Technical Service Bulletin: tsb101752

Released Date: 05-Aug-2009

Revision to Procedure 020-012, Engine Brake Solenoid Valve

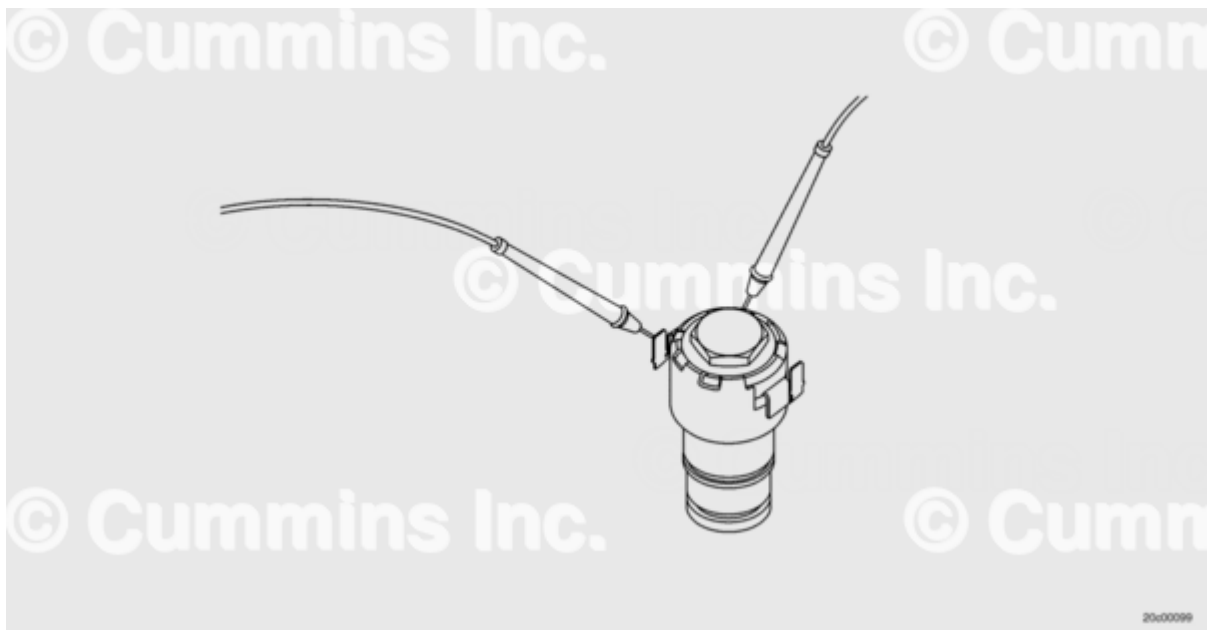
This Service/Parts Topic introduces a change in the troubleshooting and repair Procedure 020-112, Engine Brake Solenoid Valve for the Signature, ISX, and QSX15 Engines Service Manual, Bulletin 3666239. The changes made are in the Inspect for Reuse section, to resistance check values for a 12-volt supply solenoid and to the measurement method.

The cold engine and hot engine resistance values should be between 5 and 20 ohms for solenoids that require a supply of 12 volts.

The table below indicates the old and new resistance check values for a 12-volt supply:

Engine State	Old Resistance Value	New Resistance Value
Cold	8 to 10 ohms	5 to 20 ohms
Hot	16 to 20 ohms	5 to 20 ohms

In order to eliminate any measurement error, follow the steps below to check the resistance of the solenoid:

- Disconnect the wiring harness.
- Measure the resistance from the terminal to the body of the solenoid, as indicated in the illustration.
